Agenda Item **No. 5(h)**
Meeting of July 16, 2019

SUBJECT: Approving amendments to the Mission Bay South Signage Master Plan to: increase the limits of residential signage; decrease the clearance for fin signs; and to allow directional signage standards for residential and mixed use retail uses; an implementing action under the Mission Bay Subsequent Environmental Impact Report, a Program EIR; and adopting environmental findings pursuant to the California Environmental Quality Act; Mission Bay South Redevelopment Project Area

Attachment: Proposed 3E (Edwin M. Lee a Veterans and Family Community) Signage

4 BUILDING ENTRANCE SIGN - SECTION DETAIL
SCALE: 1/4" = 1'-0"

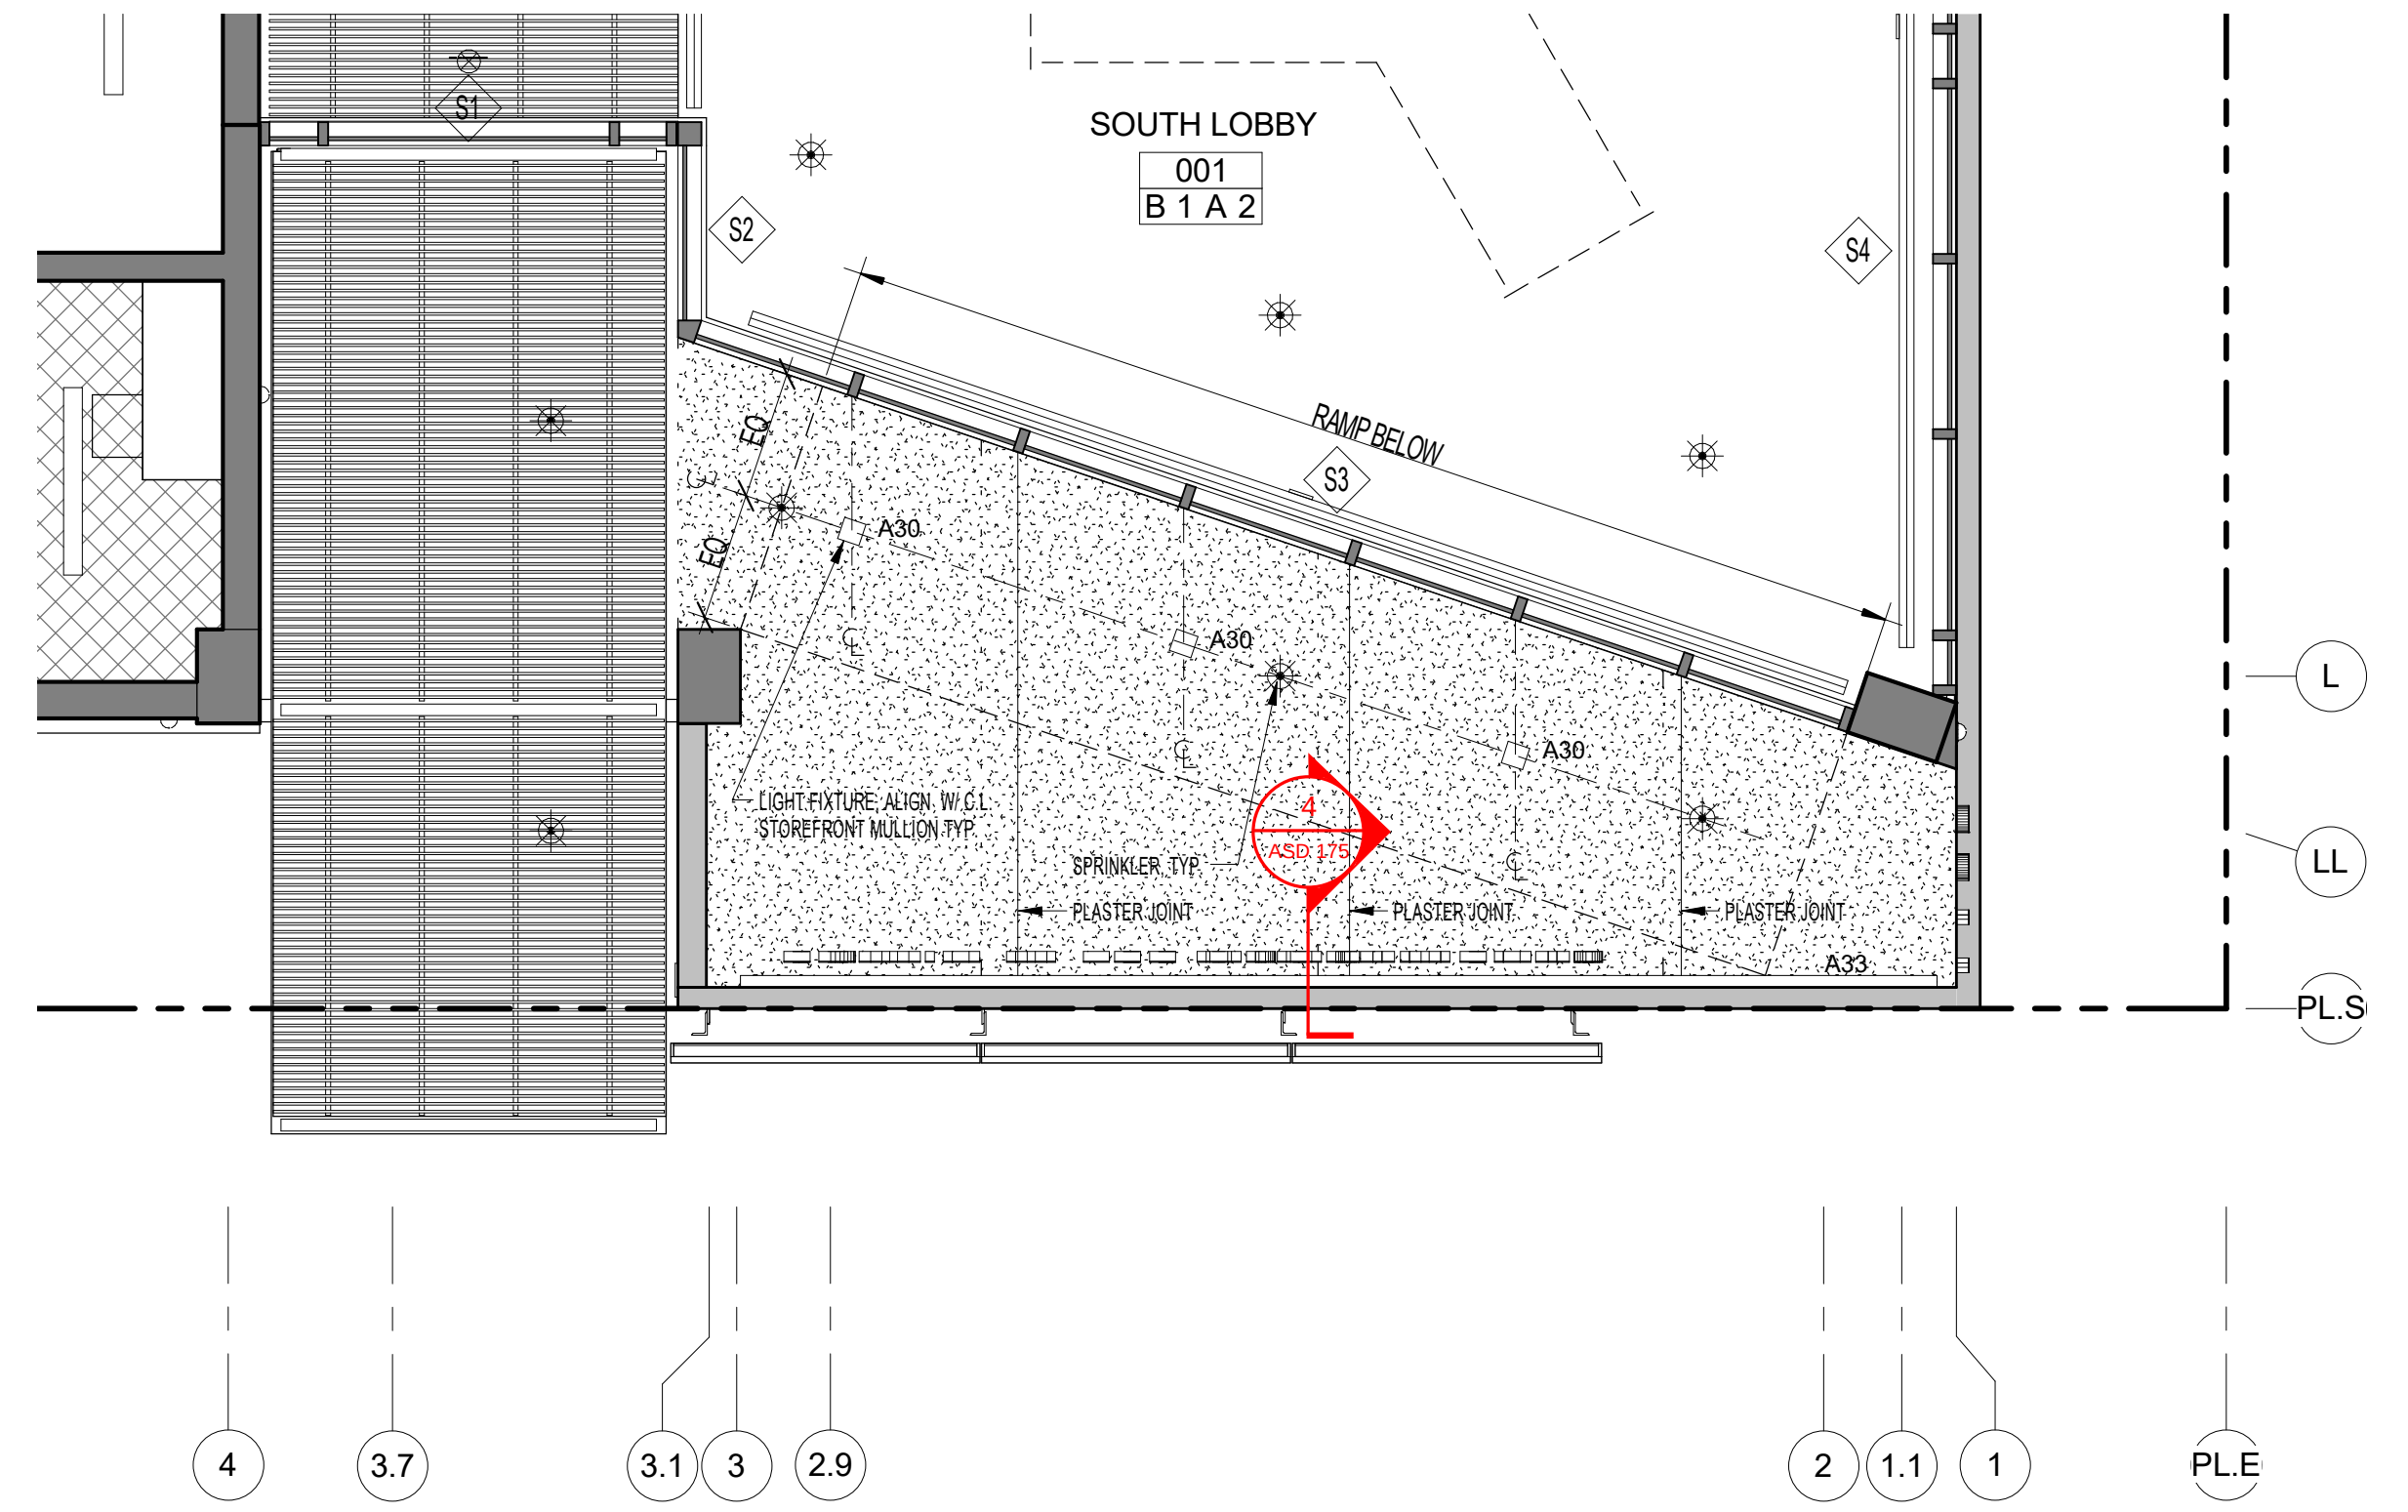
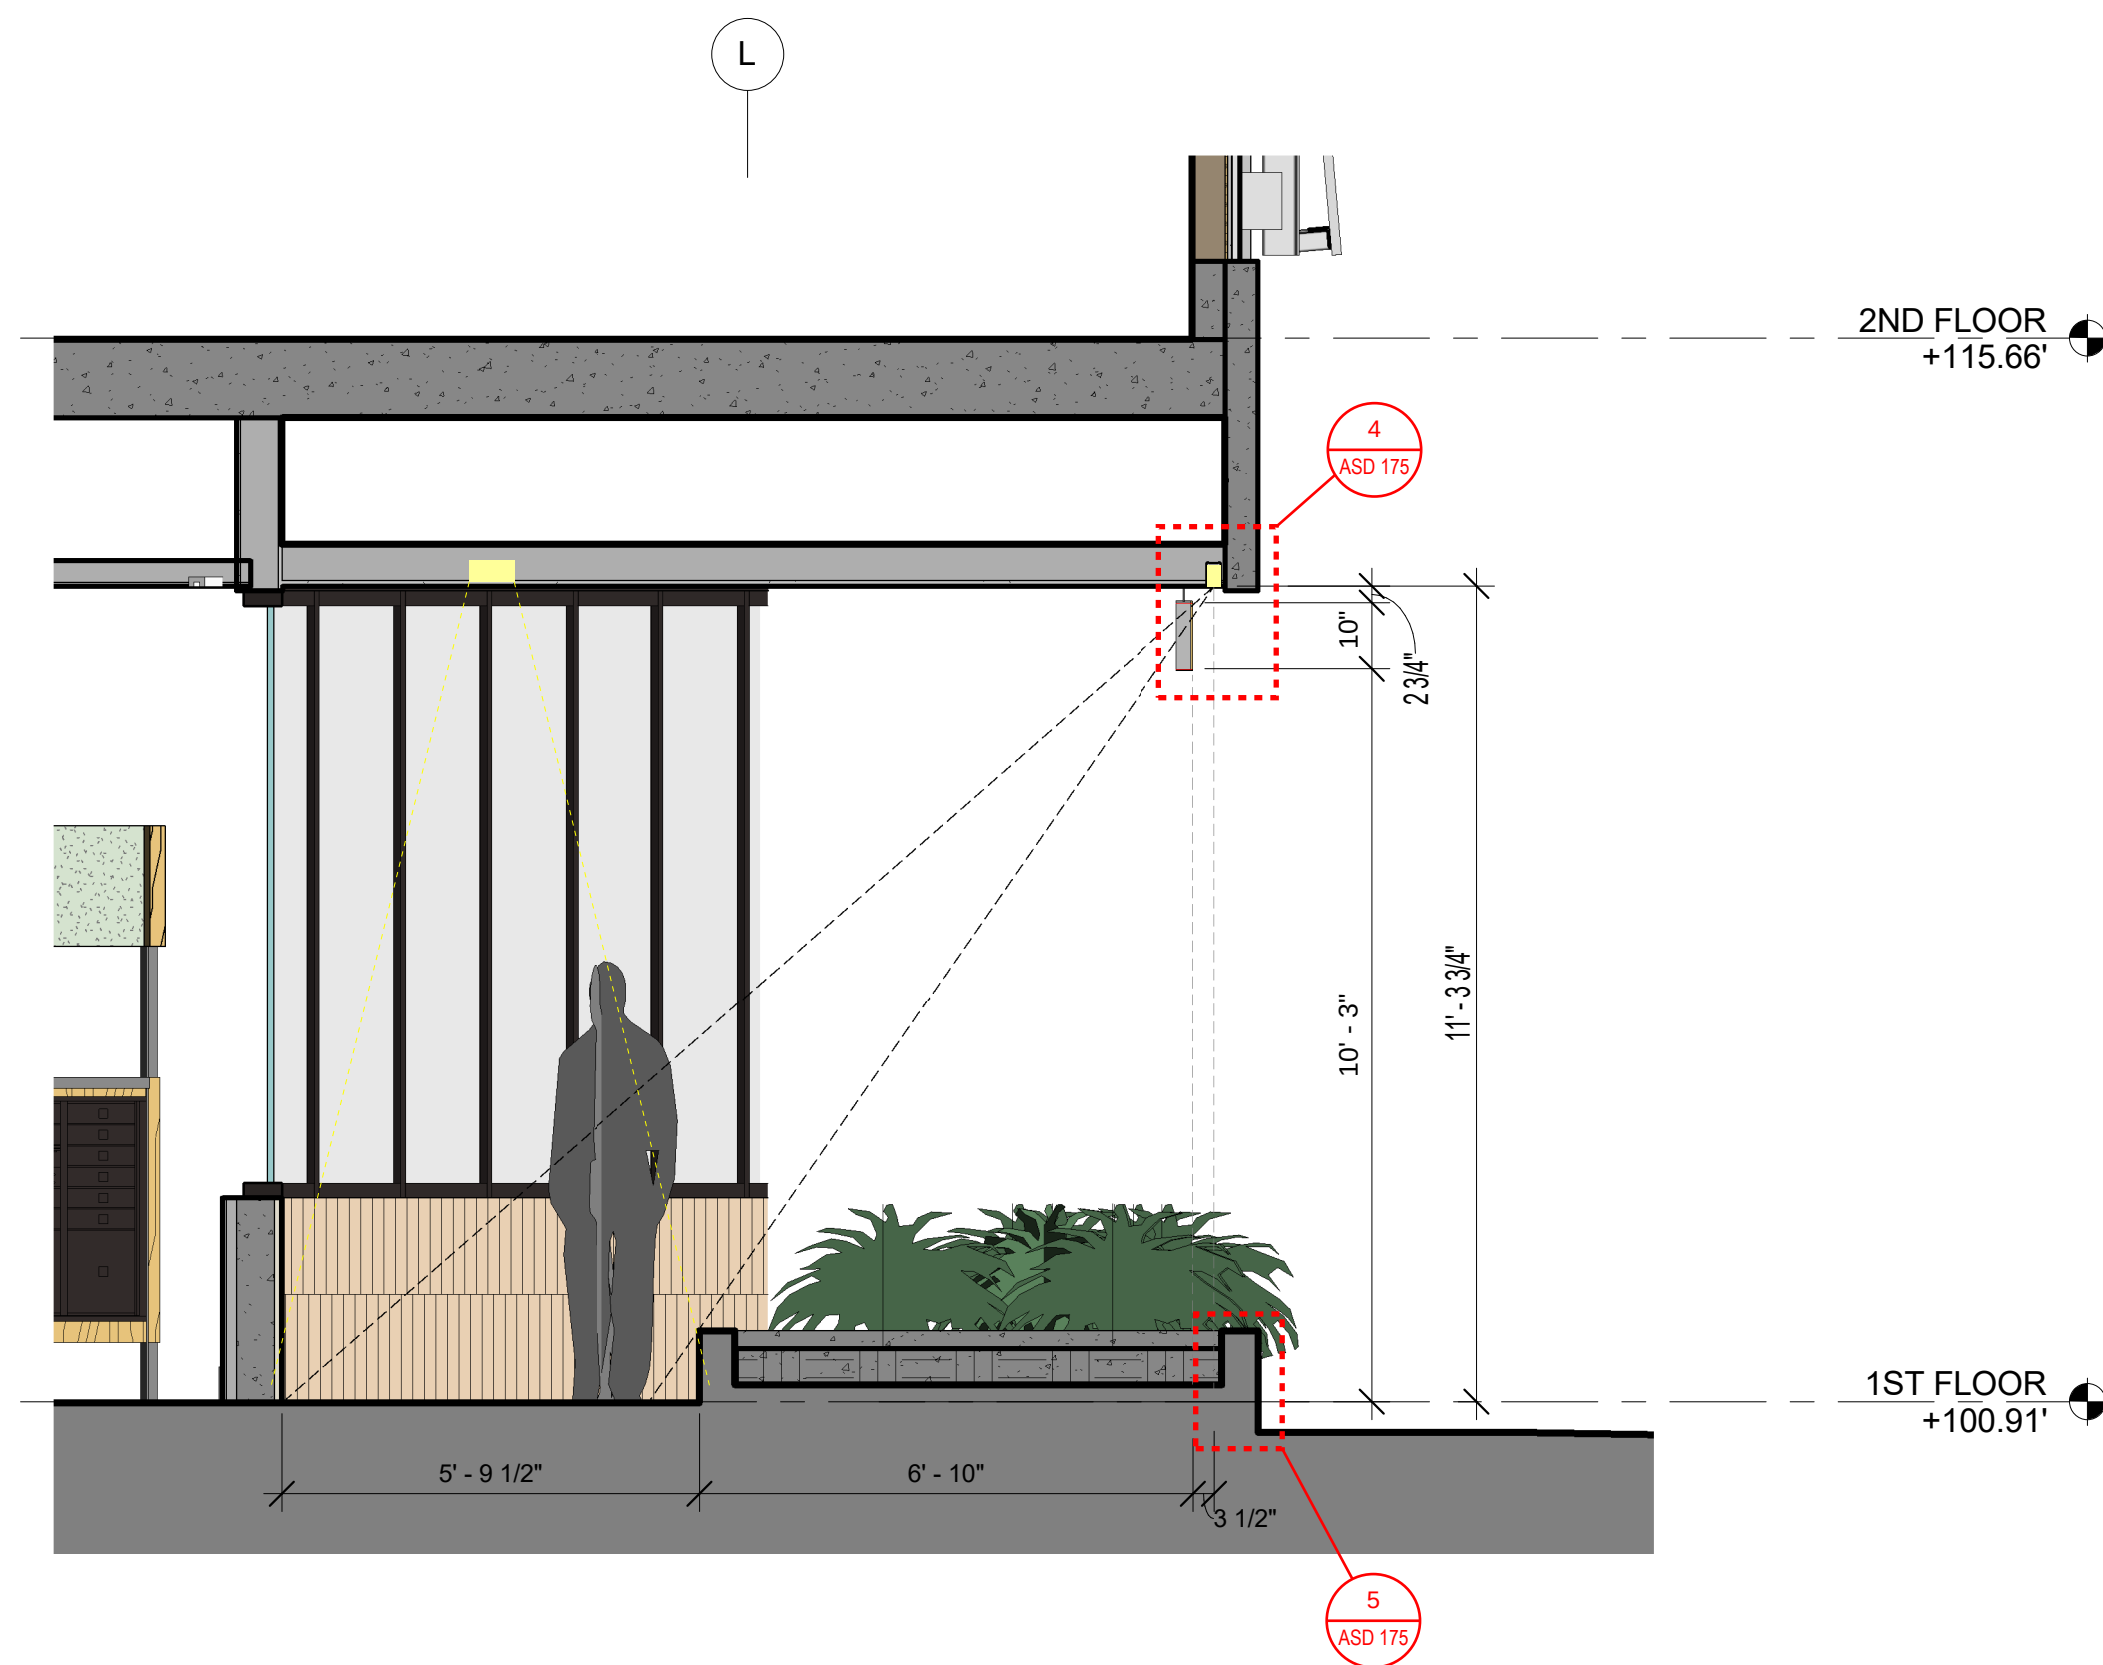
After reviewing the proposed signage for the affordable housing nearing completion on Block 3E, OCII staff determined that some of the standards are too limiting on the practical signage needs of some projects. Therefore, OCII is requesting approval of the following amendments to the Signage Master Plan: to increase the limit of residential signage on each parcel to a maximum of fifty square feet of sign area with no single street frontage exceeding thirty square feet and no individual sign to exceed fifteen square feet; to decrease the lower edge of commercial / industrial, hotel and mixed use retail fin signs from twelve feet to ten feet above the sidewalk; and to establish directional standards for residential and mixed use retail uses ("Master Signage Plan Amendments"). The proposed

The current residential standards allow for identification signage at a maximum square footage to be placed on each parcel street frontage with a slightly larger amount on 3rd and 4th streets including nameplates, wall signs and awning signs. Many projects have multiple or longer building names associated with a benefactor, a member of the community being honored, or property development firm. The current sign limits are too small and do not allow longer building names to be effectively communicated to visitors and pedestrians or vehicles passing by. Mission Bay South Block 3E, an affordable housing project, is proposed to be named after the late Mayor Lee (see attached); the current standard does not allow the building name, Edwin M. Lee a Veterans and Family Community, to be at implemented at a legible scale. The current and proposed amendment read as follows:

- The maximum signage program sign area allowed per parcel shall be 50 square feet with no single street frontage exceeding 30 square feet. Each individual sign shall not exceed 15 square feet.
